DELEGATED APPLICATION REPORT

Application No's: 24/1500

Address: Marshalls Garage, Oxford Road, Tilehurst, Reading

Proposal: Development of 32 dwellings, including 10 affordable housing units with associated parking and landscaping following the demolition of the existing buildings

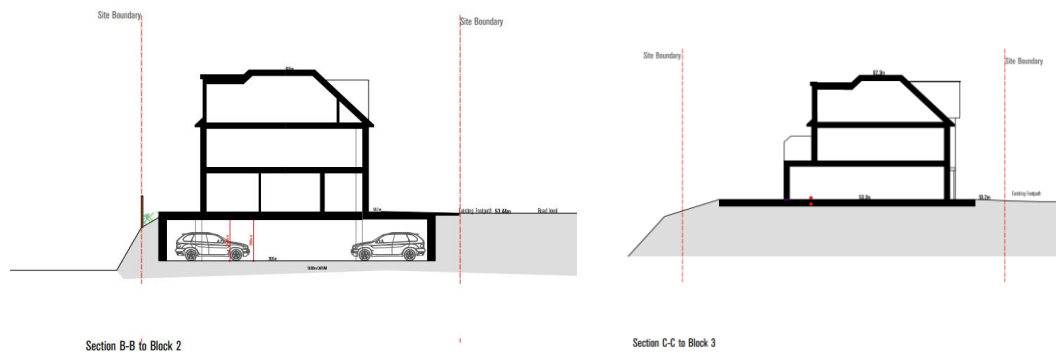
As can be seen from the proposed site plan, and whilst indicated soft landscaping is shown, there would be a dominance of built form and hardstanding across the site. The layout would appear cramped with limited space around the buildings for meaningful soft landscaping. The car park area to the east of Block 4 would have a stark appearance, as would the road and access ramp between Blocks 2 and 3.

Bin storage is proposed at the front of the site close to the highway – the bin storage for Blocks 3 and 4 in particular would be located immediately adjacent the highway. This is not considered a good design solution and combined with the cycle storage proposed adjacent the site frontage, would add to the visual intrusion of built form within the street scene.

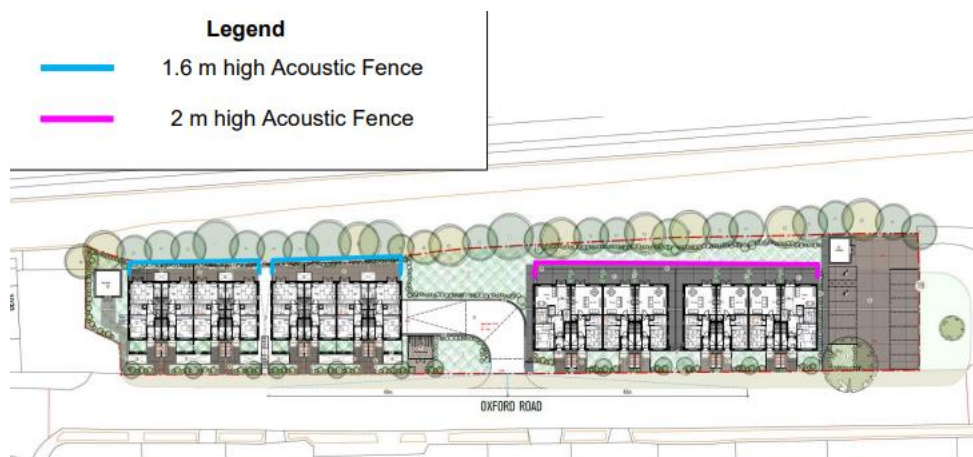
As above, the site is adjacent the railway line. Whilst Network Rail have not raised an in-principle objection to the proposals, it is apparent that significant work would be required with Network Rail to demonstrate that the site would be feasible. That such significant excavation is required to facilitate car parking is another indication of the cramped and overdeveloped nature of the proposals.
